Meeting Agenda Plat Committee

Monday, April 25, 2022

The Business Center Subd., 2022 Replat Preliminary Plat

Figure 2. Private service lines (blue and yellow lines) and a lift station connect to the City owned infrastructure.

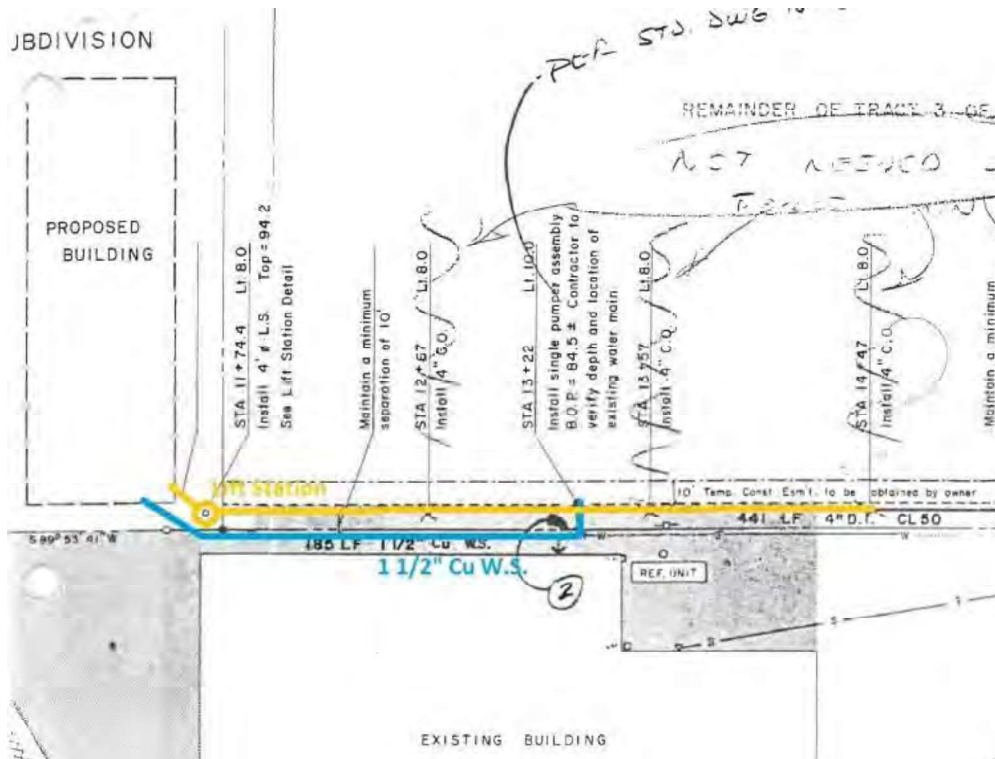
Allen also stated that the existing sewer line, manhole, and lift station located on Lot 1A, connect to city sewer but do not comply with City standards. The City's sewer main terminates prior to proposed Lot 1A (figure 2).

Figure 3. The City owned water main terminates at the privately owned service line.

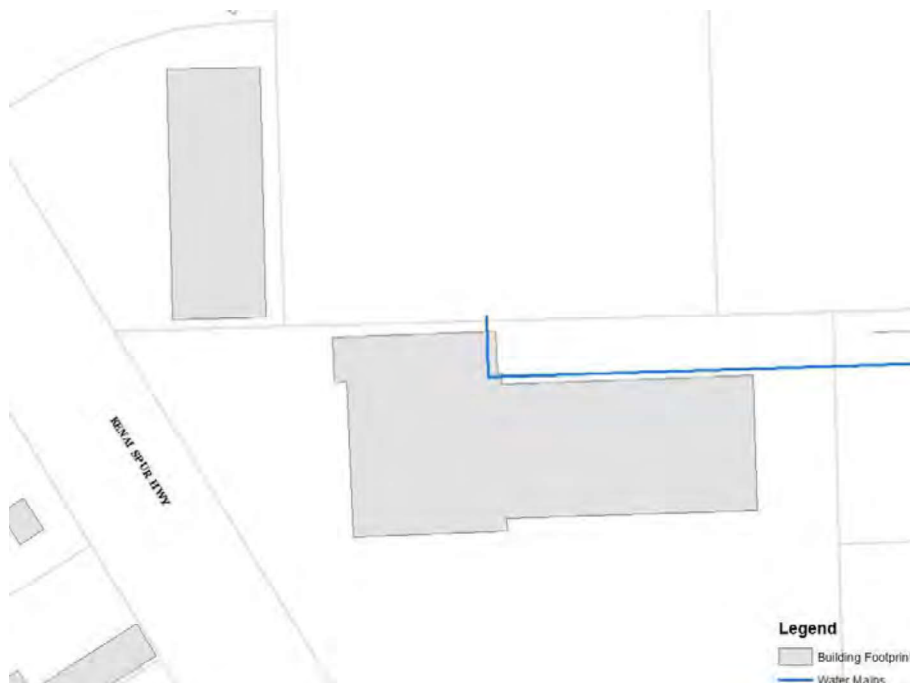
Mike Allen, the Utility Manager, stated that the sewer manhole and utility boxes depicted on the preliminary plat are not owned by the City (figure 4). The service lines that were constructed to connect to City water and sewer mains were not to City standards and are private (figure 2). The City's water main terminates prior to proposed Lot 1A (figure 3).

Vicinity Map

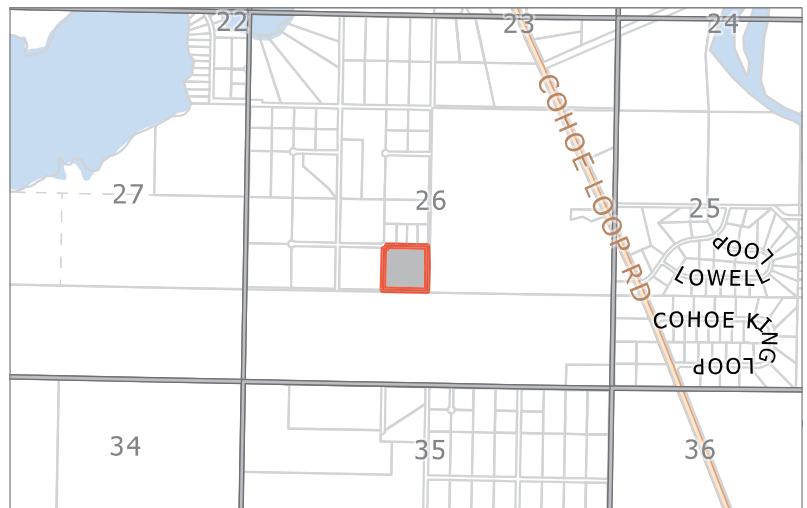
- Staff recommendation:** The official designation for Cohoe Loop Road does not have North or South designations. Please remove from the vicinity map.
- G. The status of adjacent lands within 100 feet of the proposed subdivision boundary or the land status across from any dedicated rights-of-way that adjoin the propose subdivision boundary, including names of subdivisions, lot lines, block numbers, lot numbers, rights-of-way; or an indication that the adjacent land is not subdivided;
